ADDENDUM NO. 1

IMPROVEMENTS TO WAYLAND HIGH SCHOOL ATHLETIC FACILITIES Wayland, MA

IFB #19-1030

October 4, 2018

Product Sheet**Solid Benches**

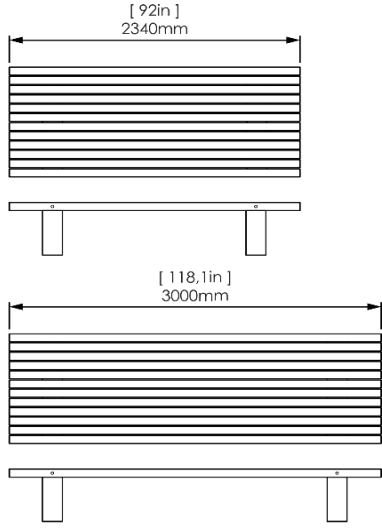
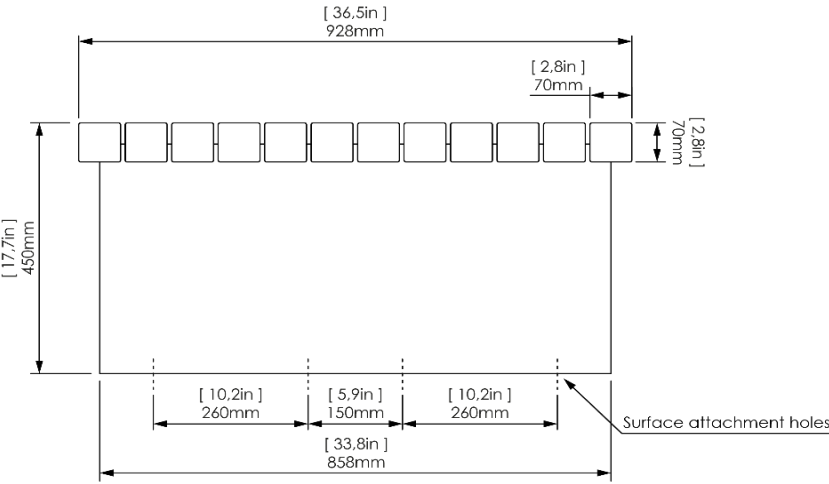
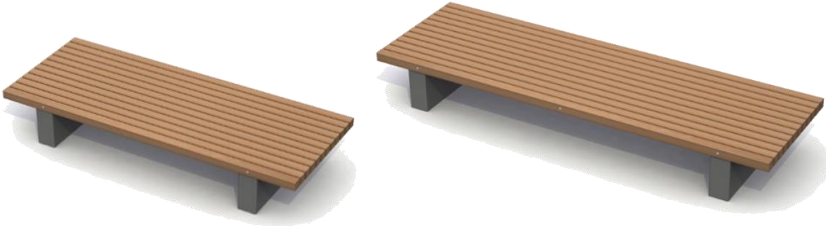
DELETE Model # L&L-L15-323 (2 total);

ADD Model # SOL-L12-234, Bench with 12 slats, 92×36×18 inches (2 total),
Model # SOL-L12-234-Ext, Extension Bench with 12 slats, 92×36×18 inches (2 total),
Model # SOL-L-SBR-180, Double sided rounded backrest, 71×6×13 inches (2 total)

MODEL
LU-0415AS

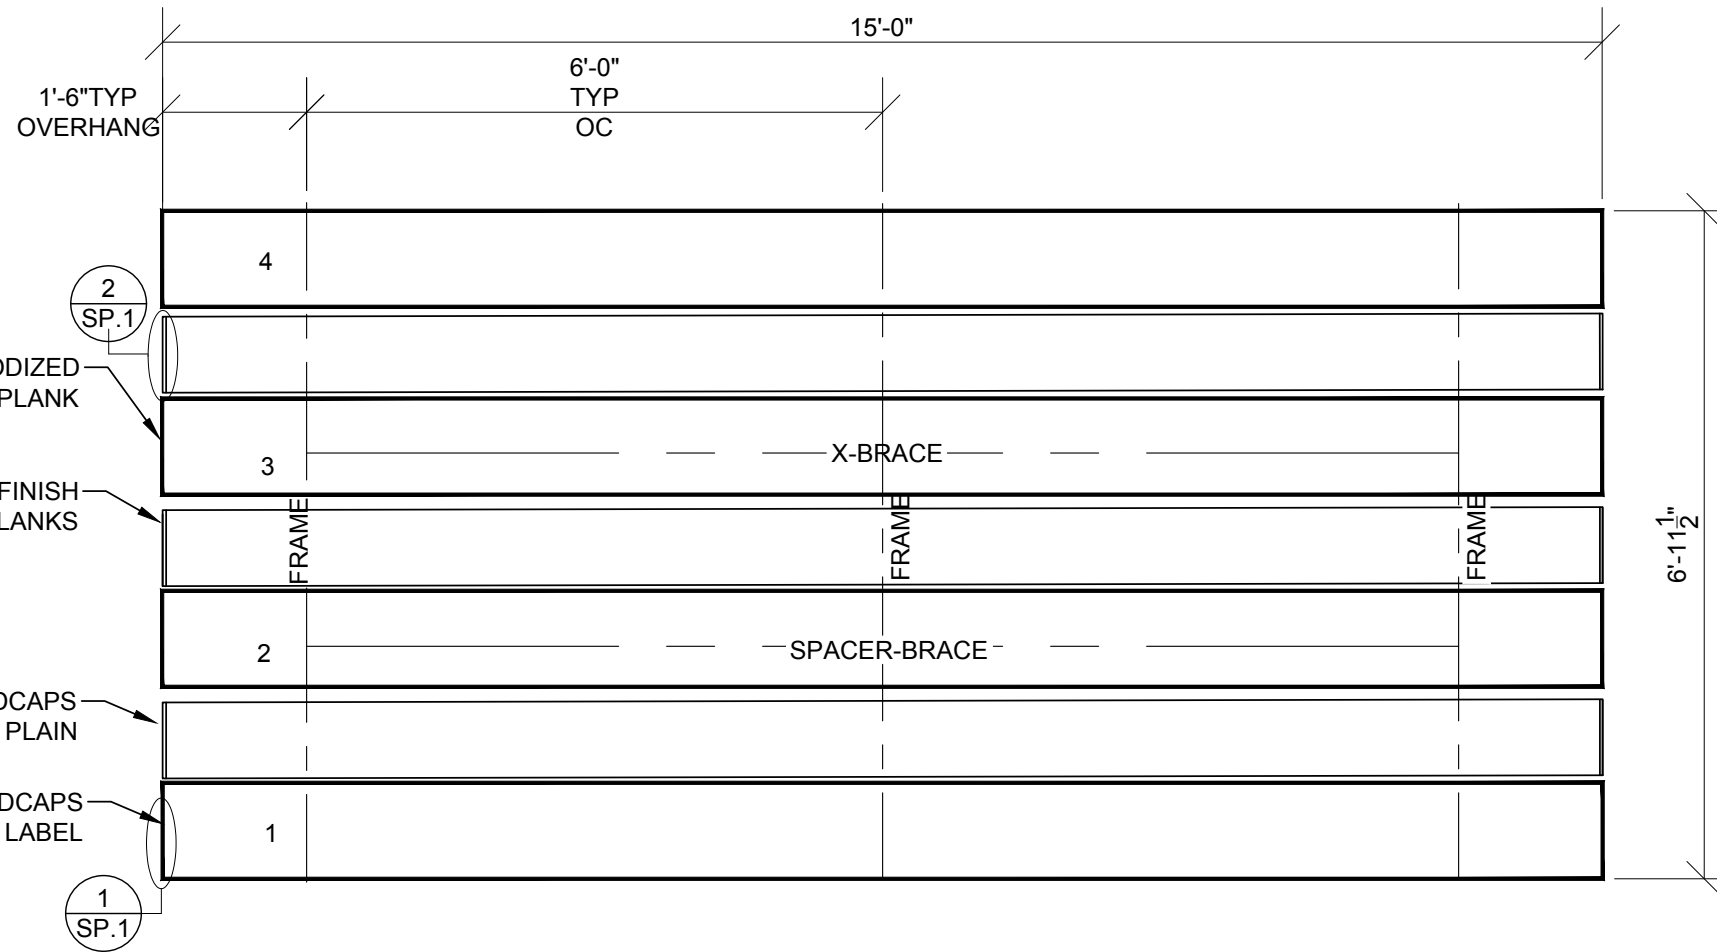
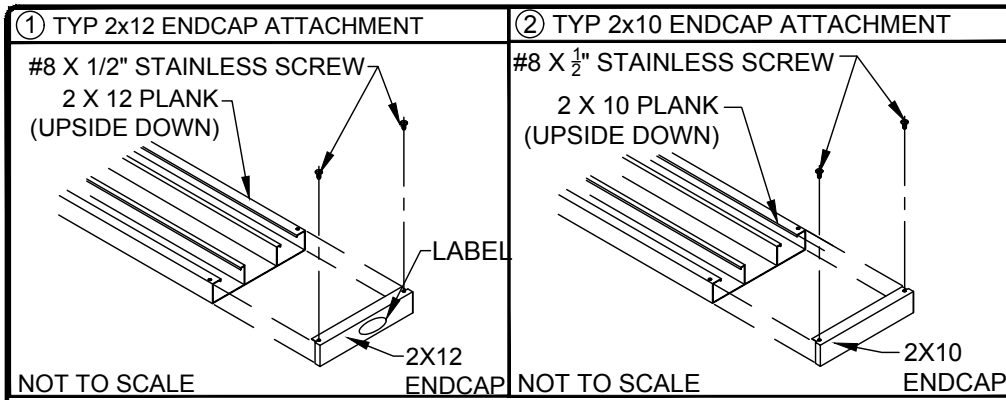
ADD: Item X. SOFTBALL FIELD BLEACHERS

The spectator bleachers at the softball field shall be Model #LU-0415AS with four (4) rows, 15'-0" length as manufactured by GT Grandstands, 2810 Sydney Road, Plant City, FL 33566, 866-550-5511, or approved equal. (2 total)

100 SERIES PL

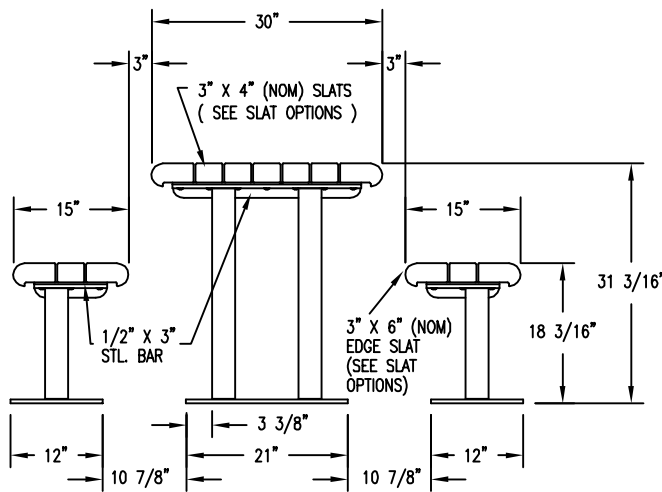
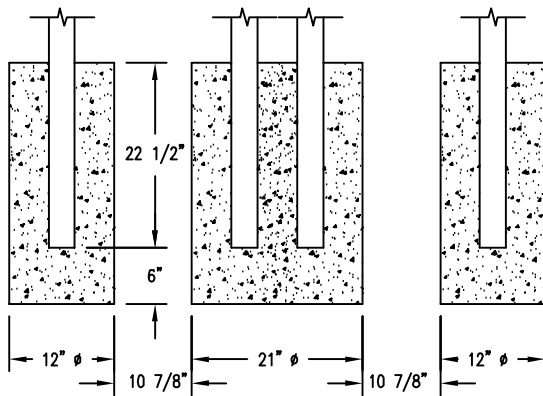
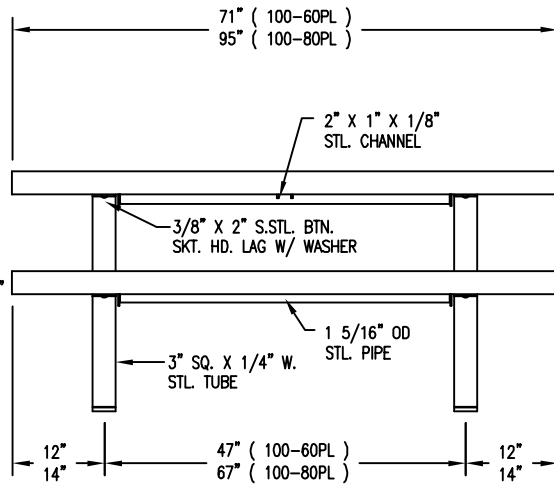
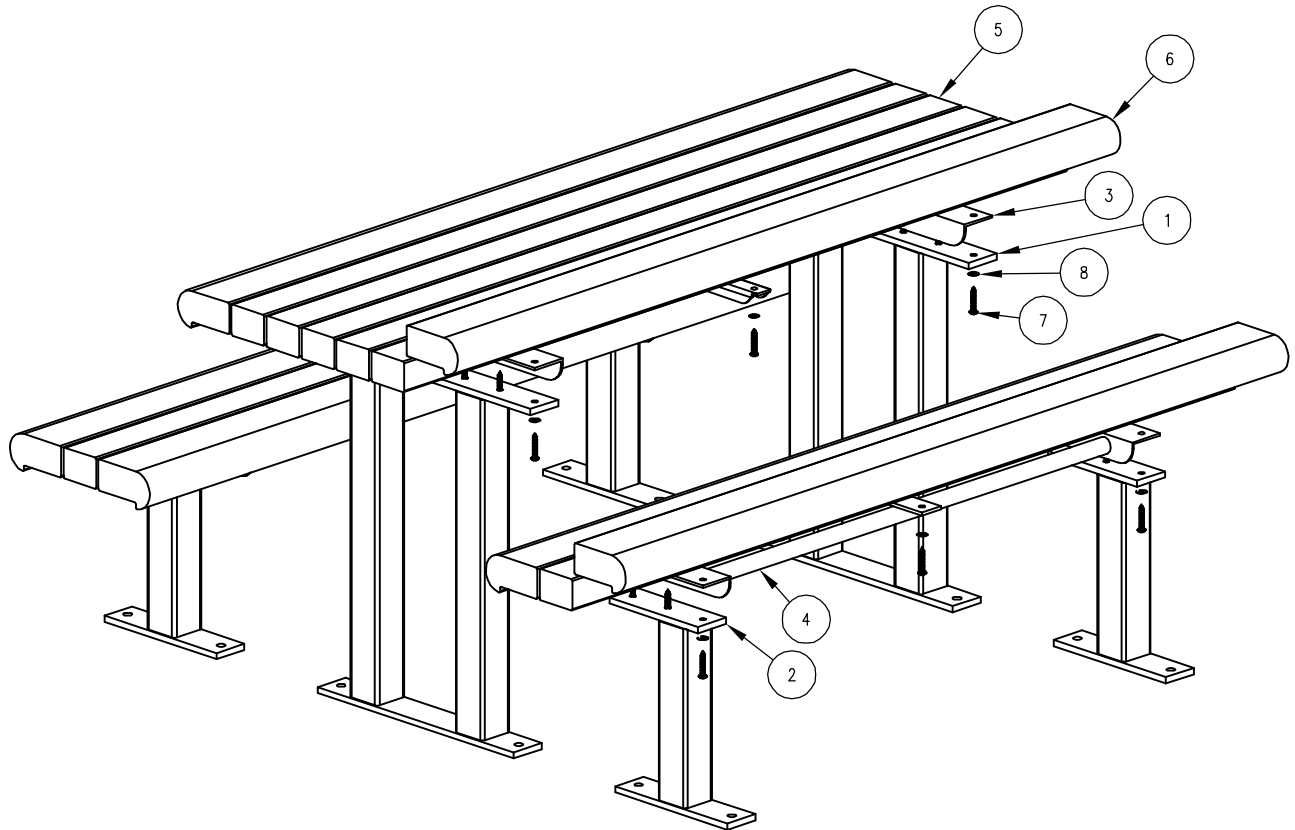
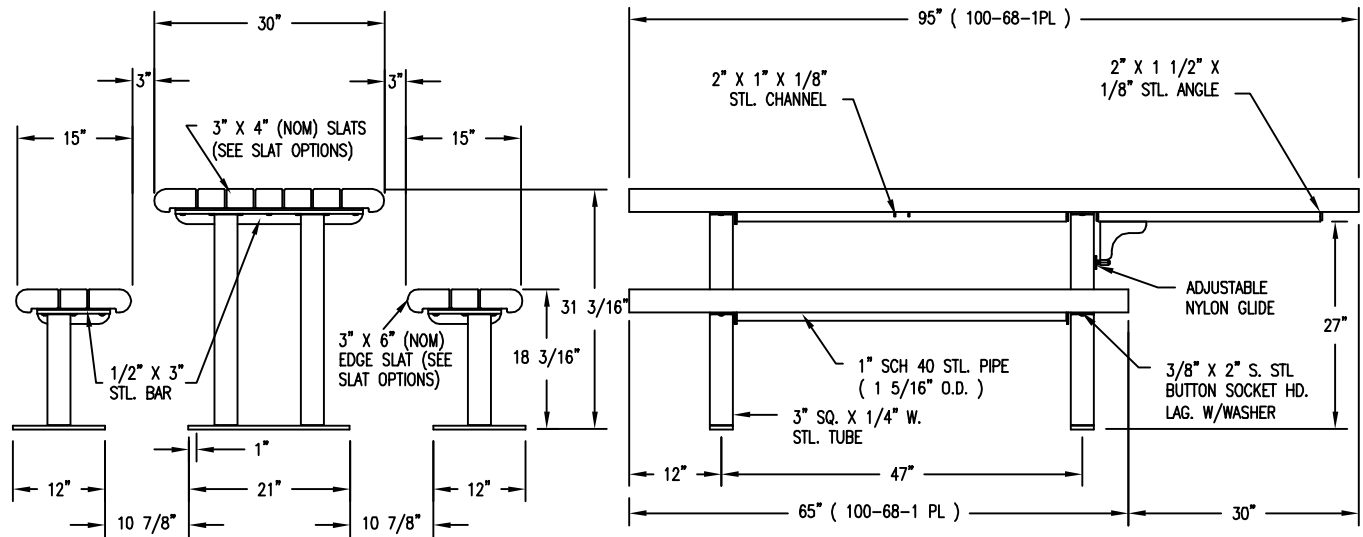
C. ADD Section 2.02 PICNIC TABLE – Standard and ADA-Compliant,

1. The Standard Picnic Table shall be Model #100 Series PL, S-2 surface mount, 6'-0" in length, "Walnut" recycled plastic as manufactured by Dumor, Inc., PO Box 142, Mifflintown, PA 017059, 800-598-4018, or approved equal. All steel members shall be coated with zinc-rich epoxy then finished with polyester powder coating. (1 total)
2. The ADA-Compliant Picnic Table shall be Model #100-68-1 PL, S-2 surface mount, 95" in length, "Walnut" recycled plastic as manufactured by Dumor, Inc., PO Box 142, Mifflintown, PA 017059, 800-598-4018, or approved equal. All steel members shall be coated with zinc-rich epoxy then finished with polyester powder coating. (1 total)

6090L

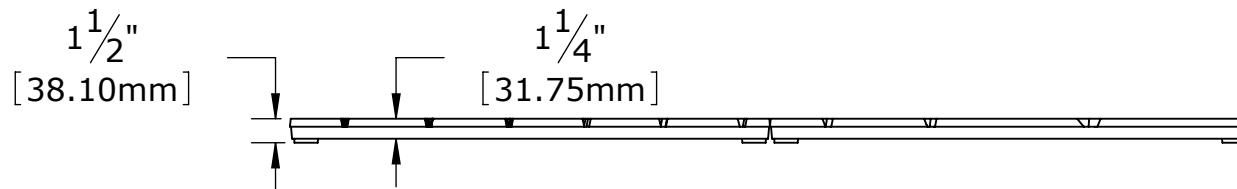
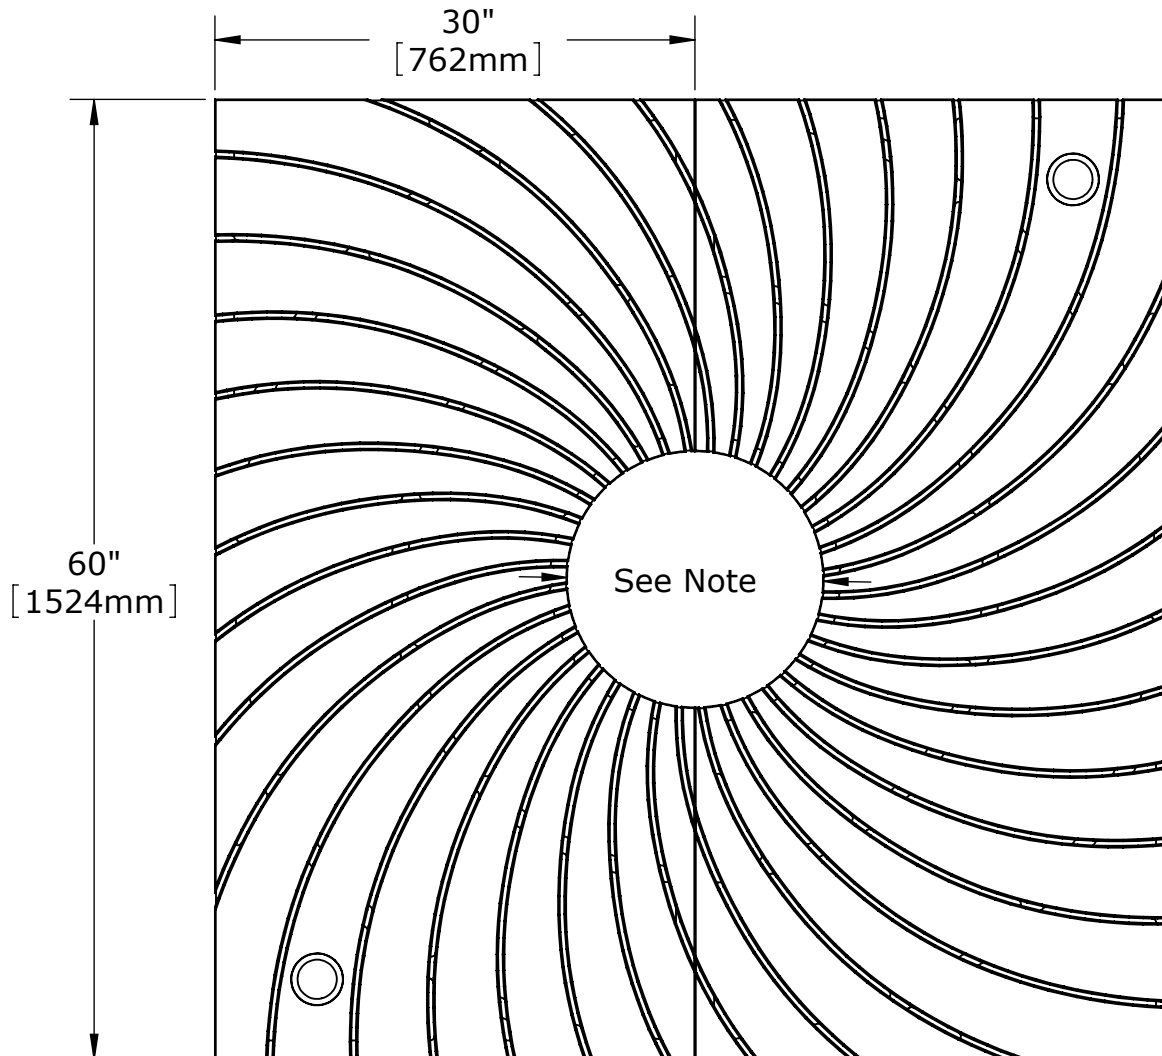
D. ADD Section 2.03 TREE GRATE

1. Tree grate shall be Model #6090L, Bond Street tree grate, 60"x60", tree grate in two sections. ½" maximum slot opening for pedestrian safety and ADA compliance. Cast from 100% recycled aluminum. Tree opening: 36"; Weight: Aluminum = 185 lb/85 kg; Finish: unfinished; Frame Model: 6000F, Finish: unfinished; as manufactured by IronSmith, 41-701 Corporate Way #3, Palm Desert, CA 92260, 800-338-4766, or approved equal.
